Addendum #4

**Bid Opportunity: 2025-RFT-001 Deep River Water
Treatment Plant Upgrades**

1.1 Updated Process Drawings to Reflect Veolia Shop Drawings

1 PHOTO 1: CONNECTION LOCATION FOR
D102 SCALE: N.T.S. MICROSAND UNIT SERVICE WATER PIPING

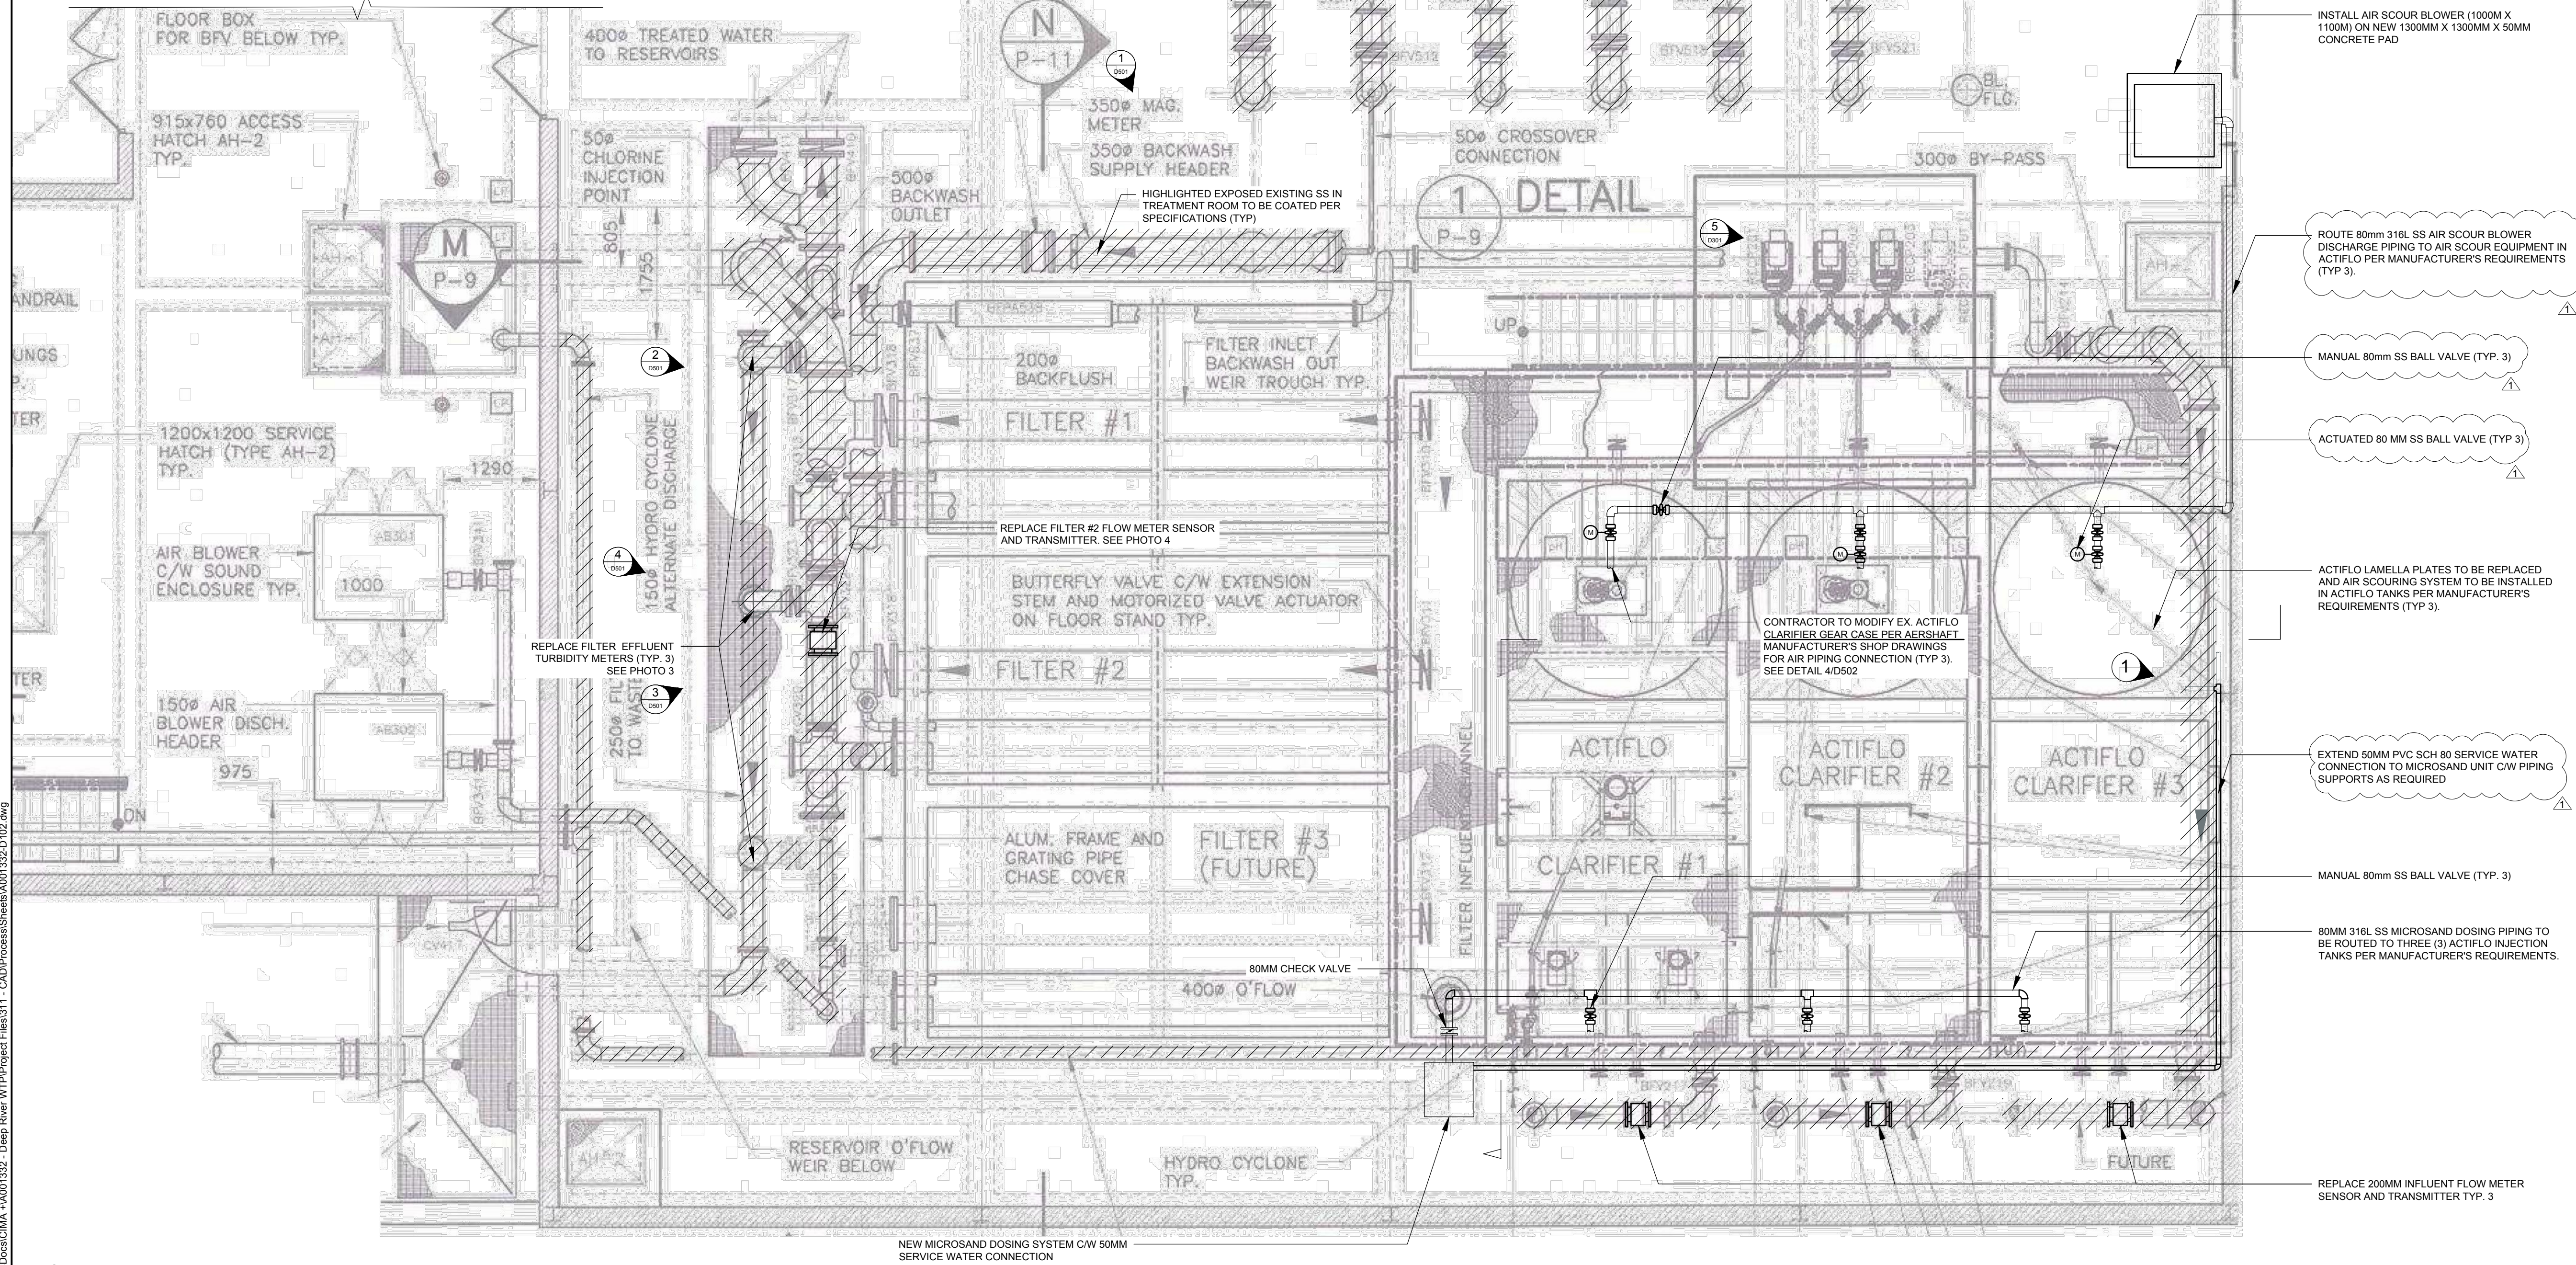
/// HIGHLIGHTED EXPOSED EXISTING SS IN TREATMENT ROOM
TO BE COATED PER SPECIFICATIONS (TYP)
